## ADDENDUM NO. 1

PROJECT: HUNT CLUB ROAD WATER MAIN REPLACEMENT PROJECT #8372

OWNER: VILLAGE OF GURNEE

## TYPICAL TRENCH AND BEDDING DETAIL STORM SEWER ONLY

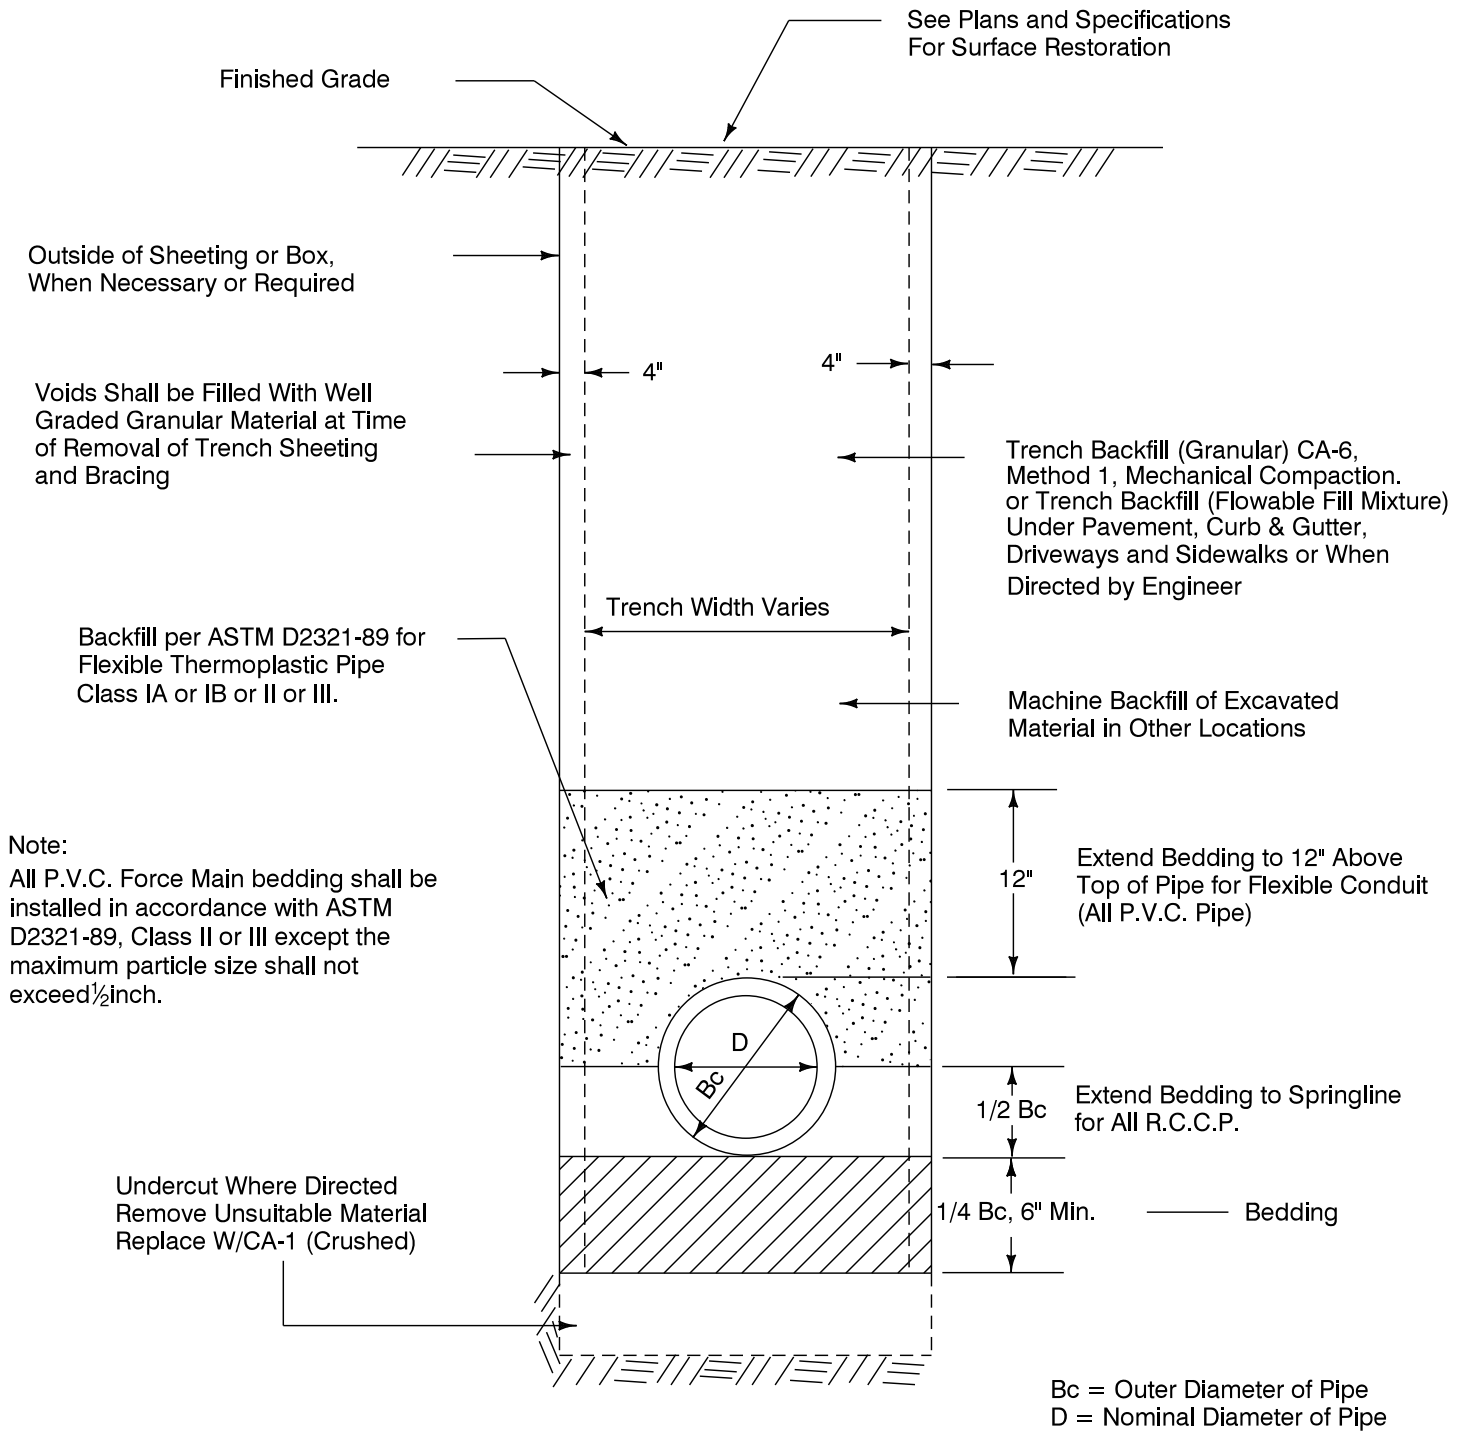
- ii. Pay item TRENCH BACKFILL will be paid for based on the Standard Details within the project plans.
2. Add the Village of Gurnee's Standard Detail for STORM SEWER ONLY

- a. Add standard detail "TYPICAL TRENCH AND BEDDING DETAIL STORM SEWER ONLY" to the bid documents.

- Remove and replace the Special Provisions page 14 of 26, in its entirety, with page 3 of this Addendum
  - Revised special provision WATER MAIN, PVC C-900, 8" & 12" (OPEN CUT)
- Add Standard Detail "TYPICAL TRENCH AND BEDDING DETAIL STORM SEWER ONLY" to the bid documents.

(Max.) Trench Widths - 9" + O.D. + 9", When trench is Less than 5' Deep  
 - 18" + O.D. + 18", When trench is Greater Than 5' Deep
